Date:	January 16, 2024
Project:	Deer Island Chenier and Cell 3
Owner:	Mississippi Department of Marine Resources
To:	Prospective Bidders
******	******

ADDENDUM NO. 2 TO INVITATION FOR BIDS

Figure 1 Planting Specifications

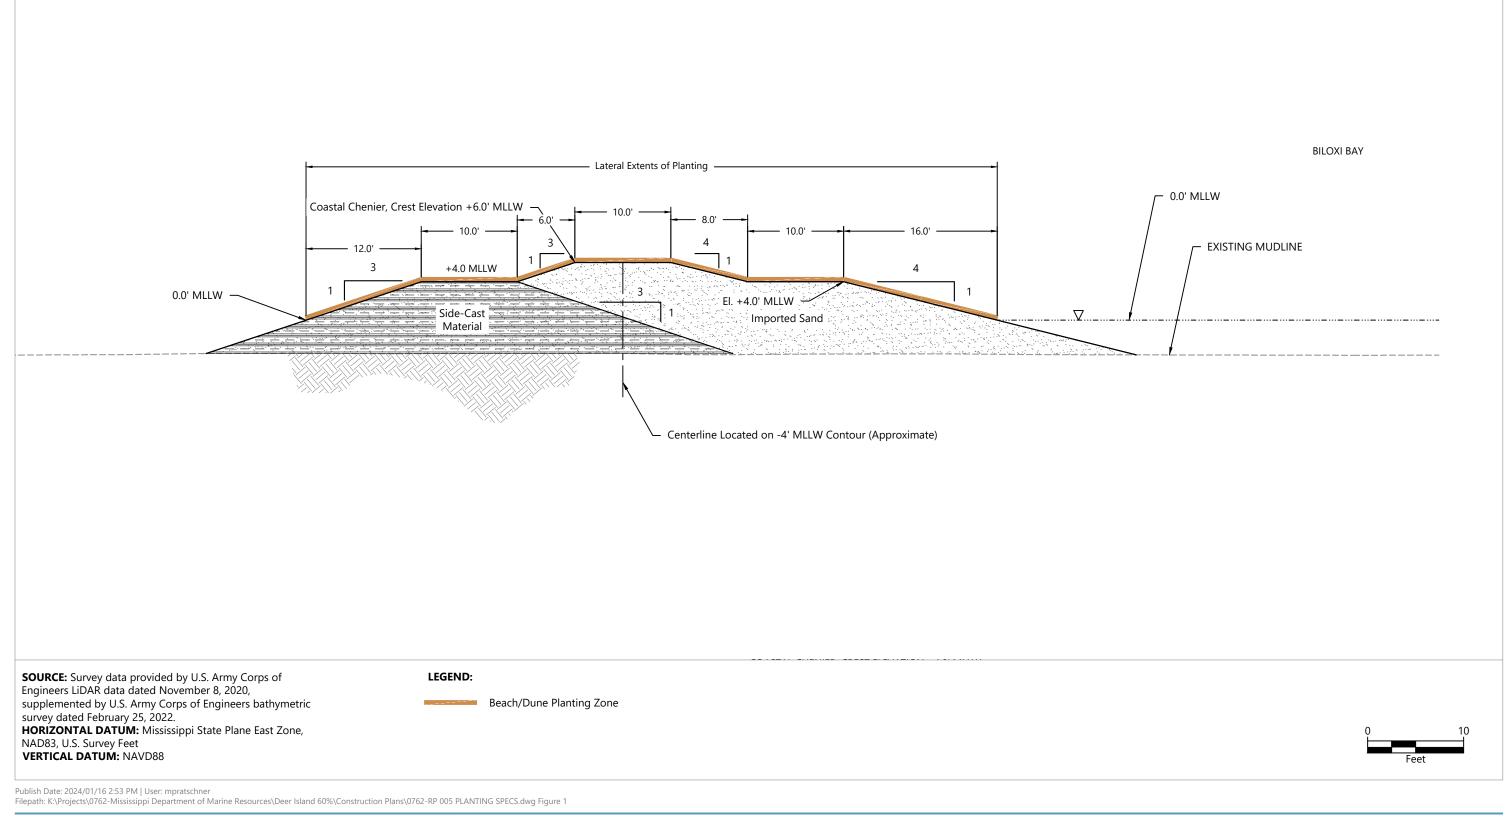
The Bid Form has been modified to include an optional Bid Item No. 1a: Planting. The requirements for the planting are as described in the attached document titled Planting Specifications.

Plant approximately 7.45 acres of beach/dune habitat in *Spartina patens* (25%), *Panicum amarum* (25%) and *Uniola paniculate* (50%) as indicated in Figure 1 on the Outer Coastal Chenier. Approximately 81,000 plants will be planted in this zone.

Vegetation should include 4-inch liner cells or larger and plant spacing should be on 2-foot centers with staggered rows.
